BSIS Proposed changes based on "ECE-TRANS-WP29-2019-28e.docx"

VRU-Proxi-11-07

Figure 1

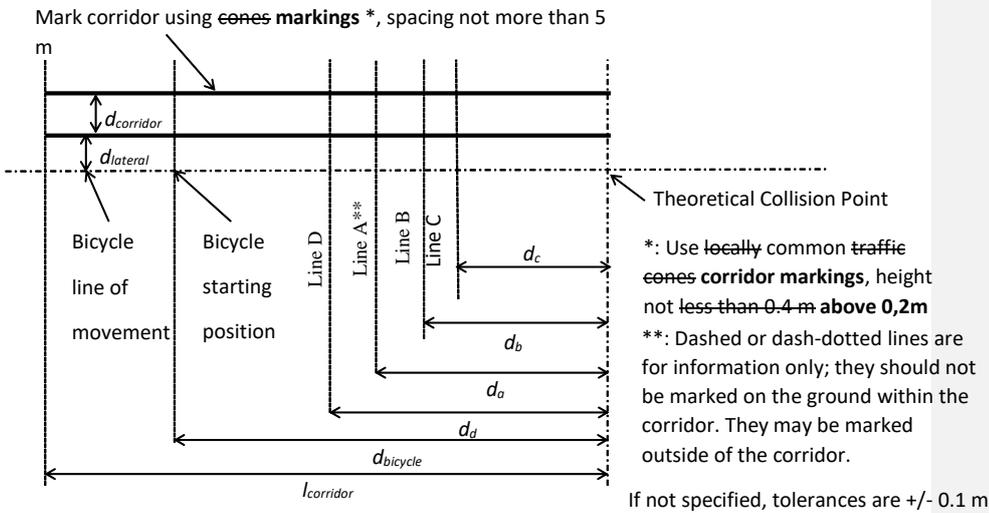
Met opmerkingen [PA1]: not clear from which point of the vehicle's external surface the distance shall be measured (the vehicle body width varies longitudinally). The reference point should be the most external edge of the vehicle body, mirrors excluded
